To: ESCOSA escosa@escosa.sa.gov.au

Re: Waterloo Wind farm stage 2 Application to Vary Generation License and add 6 turbines (V117)

Relationship to the Waterloo Wind farm stage 2 Project: abutting neighbour/near neighbour

Figure 5-1 Planning

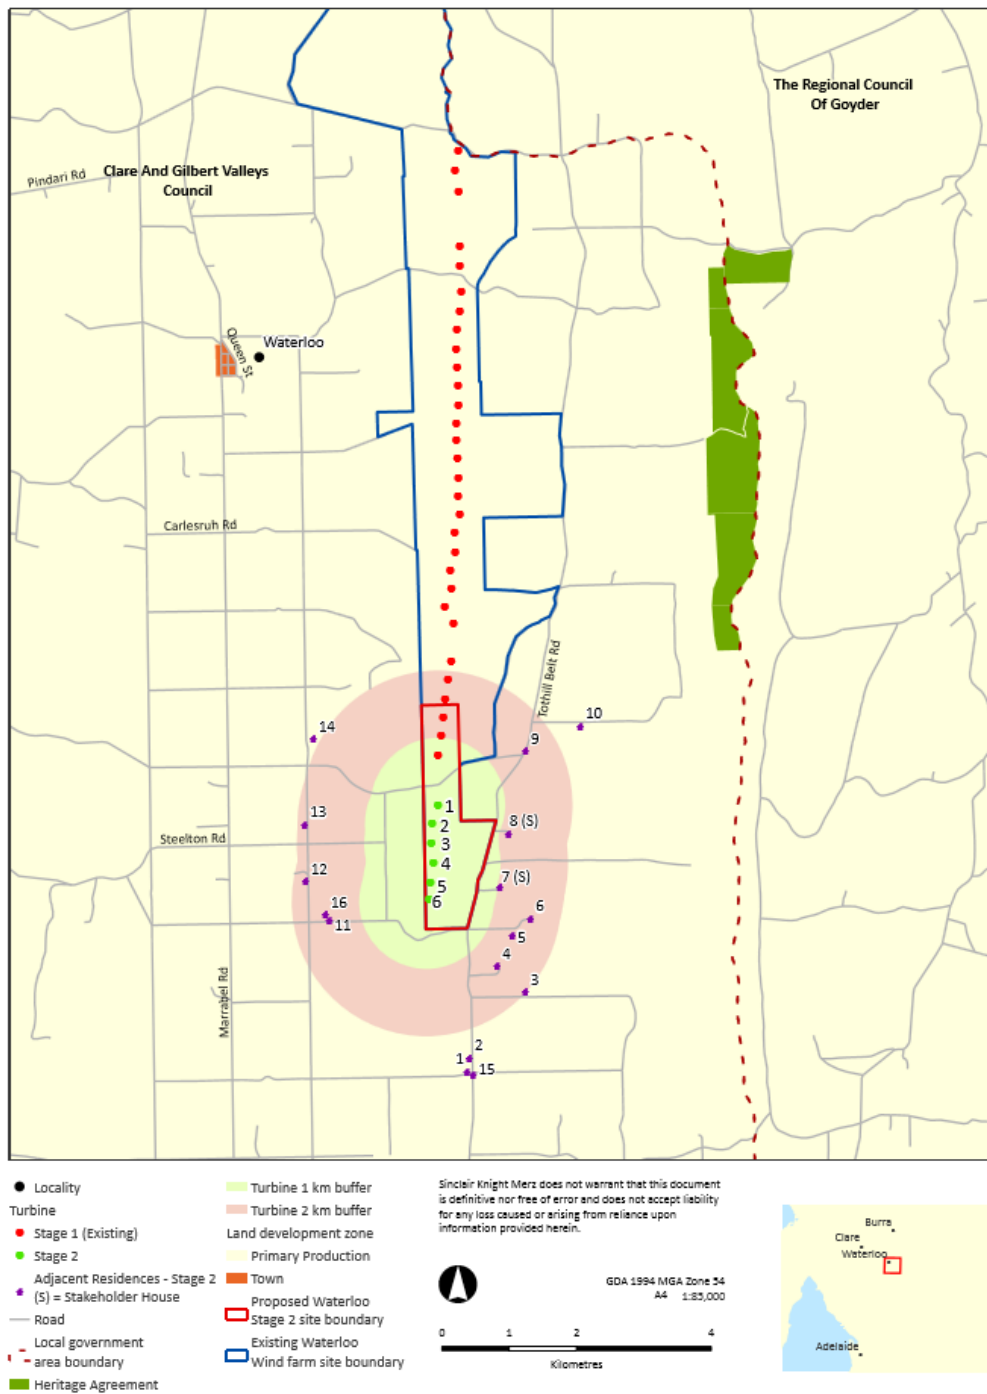
See map below from 2012 Development Application Figure 5-1 Planning. This gives a more representative view of the wind farm site and surrounds and shows how unacceptably close the turbines are sited to local houses.

10. The setbacks to houses for the Waterloo stage 2 development are insufficient, inconsistent with and significantly less than the 2 km setbacks for the neighbouring Stony Gap wind farm (proposed by the same developer and operator of the Waterloo wind farm stage 1 – Energy Australia.) Residents at Waterloo should be allowed the same 2 km setbacks as Stony Gap residents.
11. Turbines are sited too close to neighbours' boundaries. Turbine blades will over-sail neighbours land. This is an unacceptable hazard according to SAFEWORK SA submission to the 2011 Ministerial Wind farms DPA because of the risk of turbine failure. Neighbours should not have to be subjected to whirring blades immediately overhead whilst utilising their property.
